SECTION 00 91 10

ADDENDUM NUMBER 1

- 1.01 DATE: MAY 14, 2018**
- 1.02 PROJECT: AUSTIN HIGH SCHOOL CAREER TECH CENTER**
- 1.03 PROJECT NUMBER: B. C. NO. 2018112**
- 1.04 OWNER: DECATUR CITY SCHOOLS**
- 1.05 ARCHITECT: NOLA | VAN PEURSEM ARCHITECTS, PC**

ADA TOILETS
COLD WATER DIAGRAM
NOT TO SCALE

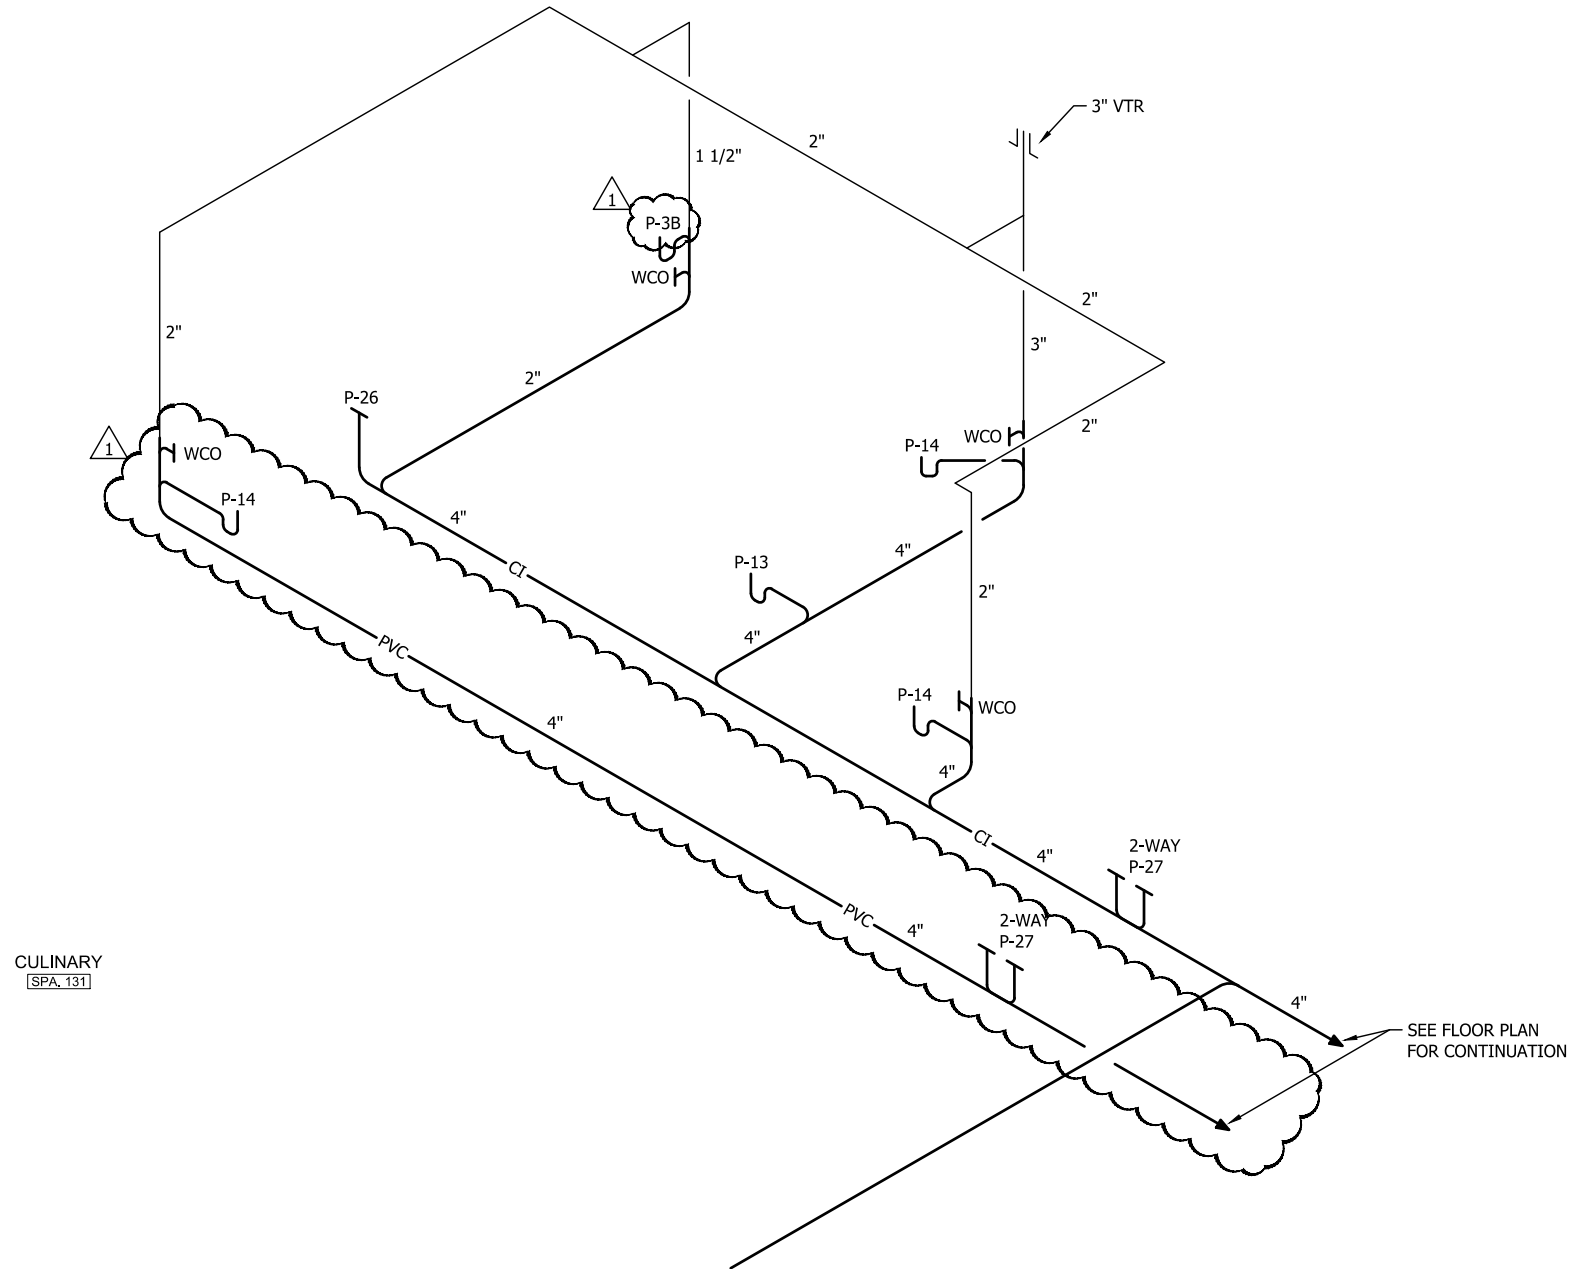
- A. Replace this sheet in its entirety, the list of changes are as follows:
1. The P-19 Exterior Wall Hydrant on the south wall has been moved. The Cold Water Diagram has been changed to match the change on the floor plan.
